Inspection Report For Well: UT20736 - 06603

Step Rate Test (SRT) Analysis

RE: EPA AREA PERMIT NO. UT20736-06603
Change of maximum surface injection pressure
Ute Tribal 16-07 SWNE Sec. 16-T5S-R3W, Duchesne County, Utah

Re: Underground Injection Control (UIC): Change in Maximum Allowable Injection Pressure on the Ute Tribal 7-15 Well (EPA Well # UT20736-06603, API # 43-013-31854) - Antelope Creek Oil Field, Duchesne County, Utah

EPA's Verifaicon of Step Rate Test Analysis

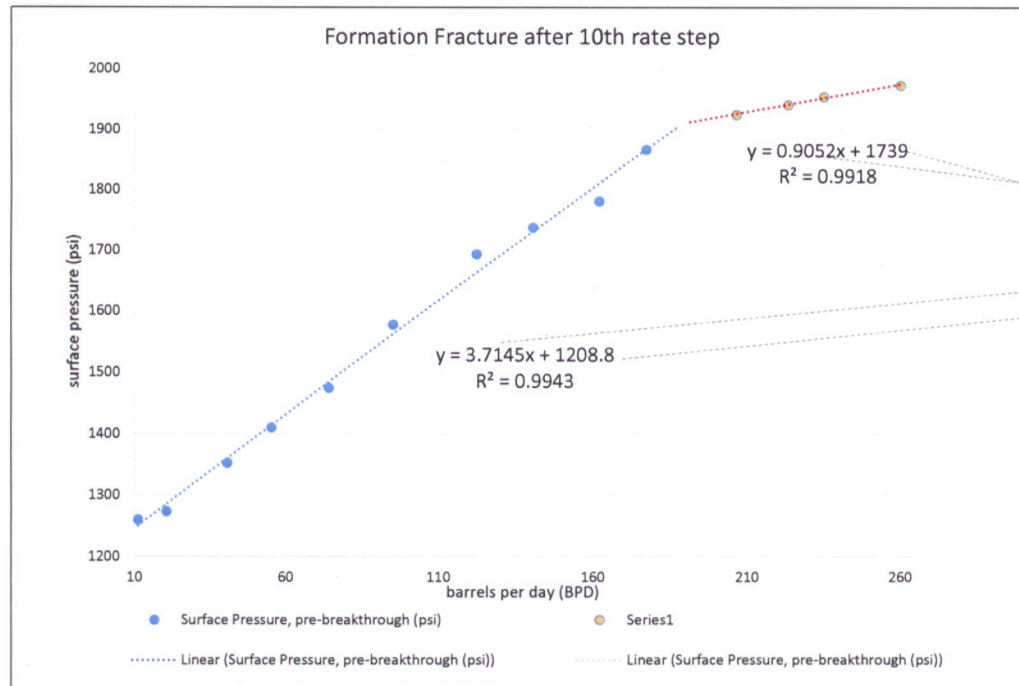
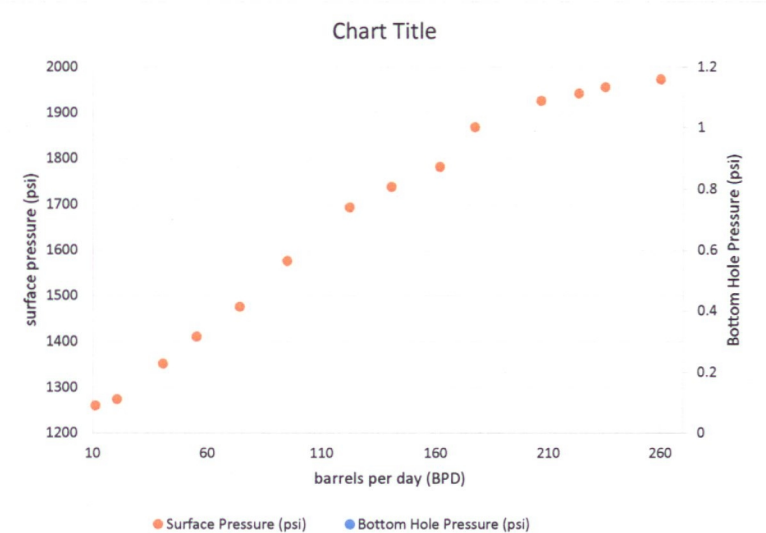
- 1) Enter verified Rate and Pressure data into table
- 2) Look at scatter plot to left and determine rate step where formation fracture seems to occur.
 - a) If this point is obvious, enter the m and b values from trendlines on corresponding chart below into table (cell D18) to solve for P_{fp}.
 - b) If this point is not obvious, enter the two values for R² off the charts that represent possible data fits in column L. Look at the R² summary table to determine which results in the best fit (Sum R² value closest to 2.0). Then enter the m and b values from the trendlines on table to determine which results in the best fit Sum R² value
- 3) P_{fp} value is automatically entered onto SRT analysis tab. Enter sg, Depth to top perf, and ISIP on that tab to solve for FG (and MAIP).

For the graph that results in the best fit (Sum R² value closest to 2.0), Enter the following values from the two linear equations to solve for P_{fp}.
(linear equations in form y = mx + b)

→ m₁ = 0.9052
→ b₁ = 1739
→ m₂ = 3.7145
→ b₂ = 1208.8

P_{fp} = 1910 psi

BPD @ P_{fp} based on pre-breakthrough trendline 189.0
BPD @ P_{fp} based on post-breakthrough trendline 189.0

The Step Rate chart:

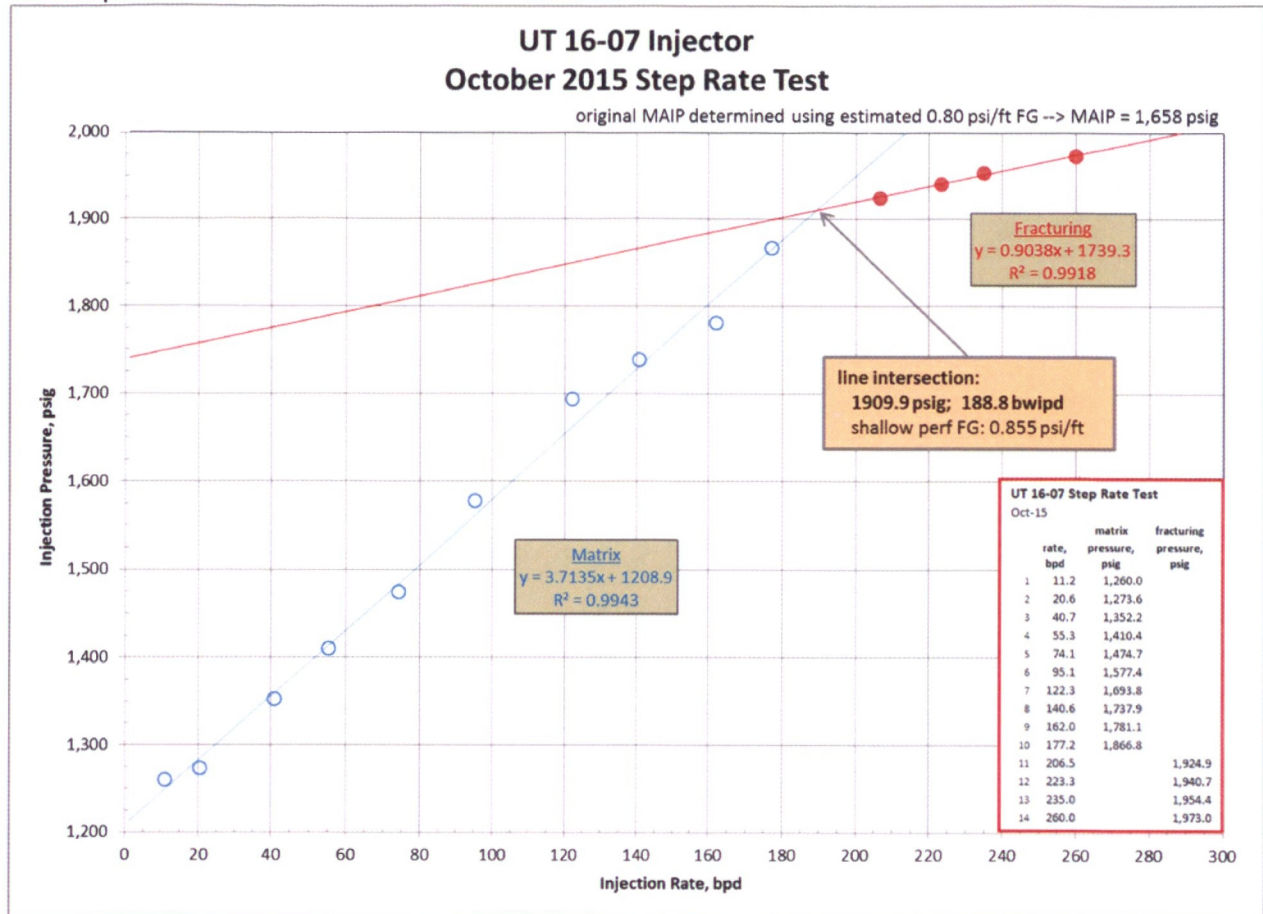
The resultant step rate plot indicates a fracturing point intersection at:

1,909 psig

188 bwipd

FG: 0.855 psi/ft - to the top perf

Based on this test, we believe the MAIP should be adjusted upwards to 1,909 psig.
